SERVICE BULLETIN: JSB 004-4

Issue: 4

Subject: Jabiru Engine Oil Pump / Cooler

Affected Models: Jabiru 2200 and 3300 engines

Figure 1. Front Side of Port Plates (Tractor Installation)

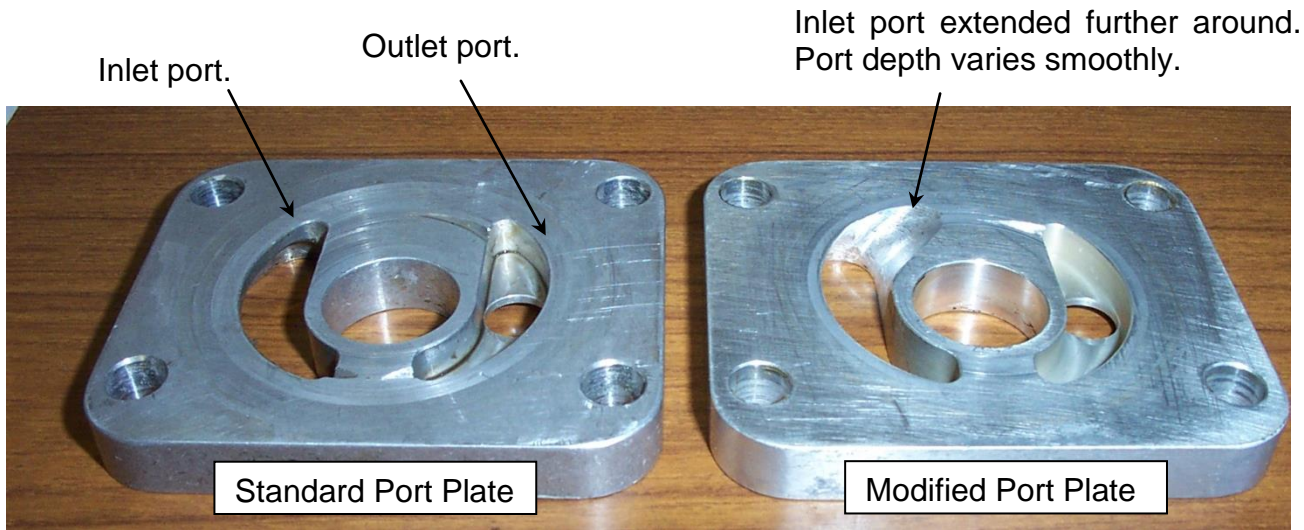
The oil pump port plate can be reworked to reduce cavitation. Refer to Figures below. This change supersedes the port plate modification detailed in **Issue 3** of this Bulletin.

- e) Place the port plate back on the engine. Ensure that the plate is oriented correctly, as shown in Figure 1. The inlet port is on the Passenger's side of the aircraft (tractor installation). The less symmetric face of the port plate (the side with one large, curved port and one smaller, round port) mates to the crankcase.

Figure 3. Port Plate Evolution

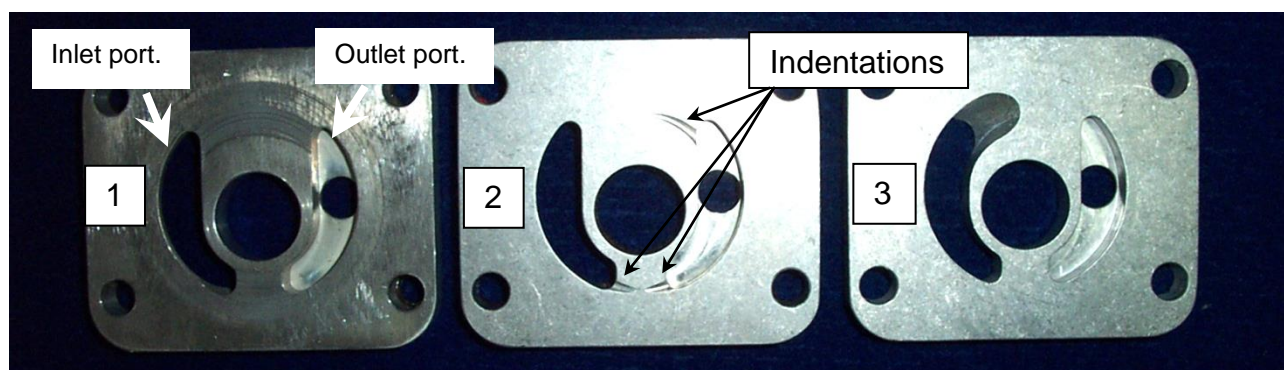
The Figure above shows 3 different styles of oil pump port plate.

Plate #1: This is the original design, with the port plate outline unbroken by indentations.

Plate #2: This is a more recent design. At the top of the outlet port and at the bottom of both ports there are small tapered indentations. Some versions of this plate will only have the larger indentation at the top of the outlet port, and not the pair at the bottom.

Plate #3: This is the current plate design. The small indentations have been replaced by a large tapered cut at the top of the inlet port. Changes have also been made to the other side of the plate (which faces the crank cases) to remove sharp edges & reduce cavitation.

Plates like Plate #1 & Plate #2 can be modified to be equivalent to Plate #3. Where the plate already has the indentation on the top of the outlet port, care must be taken to leave at least 2mm between it and the end of the new cut on the inlet side.
